City of Portland, Maine - Building or Use Permit Application

Location of Construction:	31 SUMMIT ST	Owner Name:	JOHNSON WESLEY D & AMY F	Phone:	
Business Name:		Contractor Name:	C W Hannon Excavating	Contractor Address:	31 SUMMIT ST
Lessee/Buyer's Name:		Phone:		Portland	
				Permit Type:	Alterations - Dwellings
					Zone: R-2

Proposed Use:	Single Family Removing and replacing existing foundation that is crumbling. Interior renovations of new foundation	FIRE DEPT:	<input type="checkbox"/> Approved <input type="checkbox"/> Denied	INSPECTION:	Use Group: R3 Type: SB
Proposed Project Description:	Removing and replacing existing foundation that is crumbling. Interior renovations of new foundation	Signature:		Signature:	JMB 7/27/06

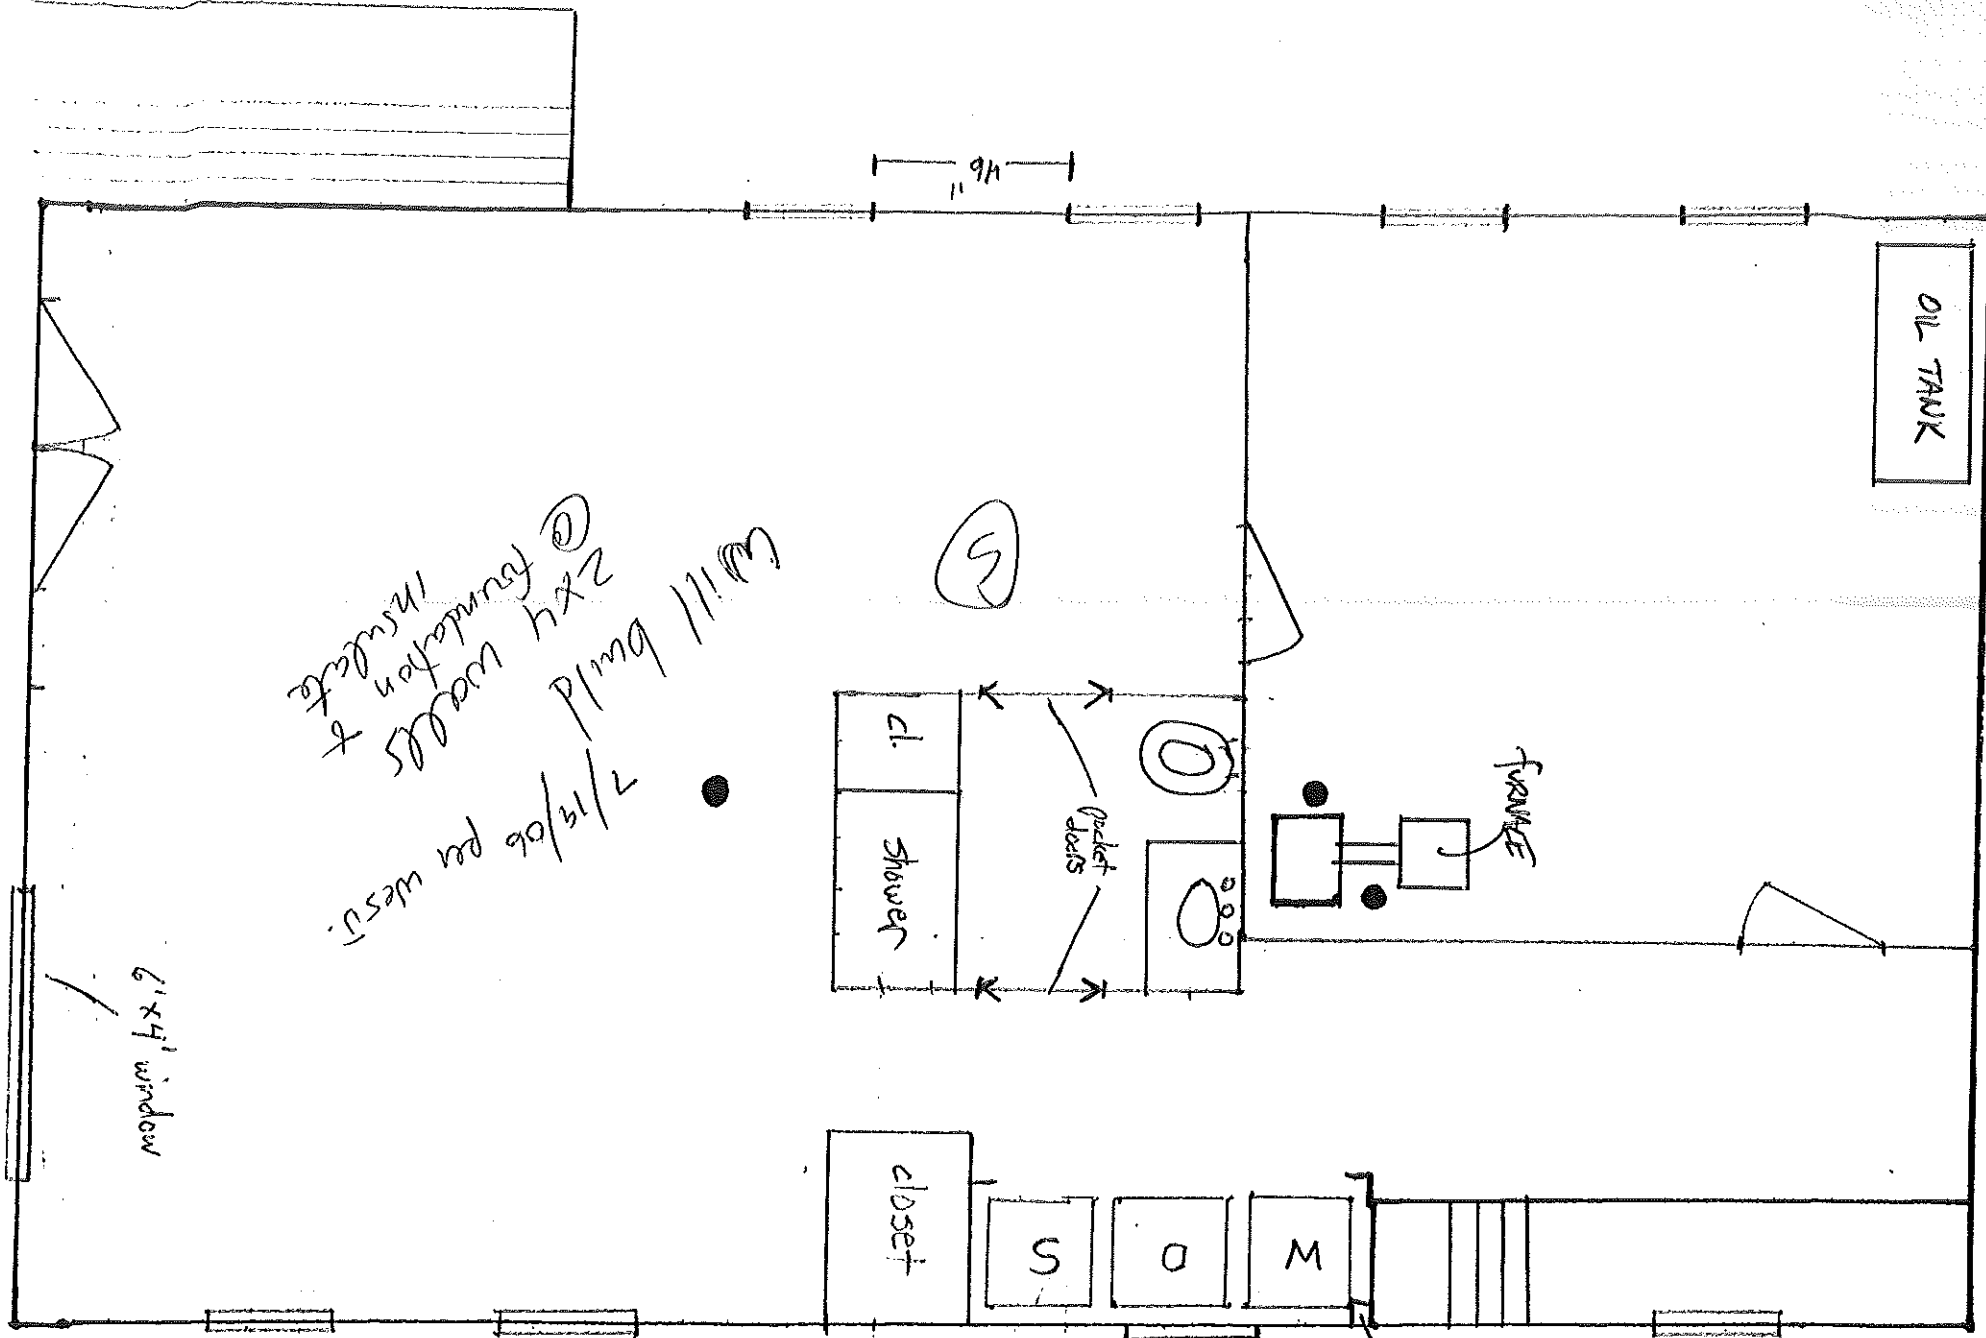
Will build
@ 2x4 joists
foundation &
insulate
7/12/06 per west.
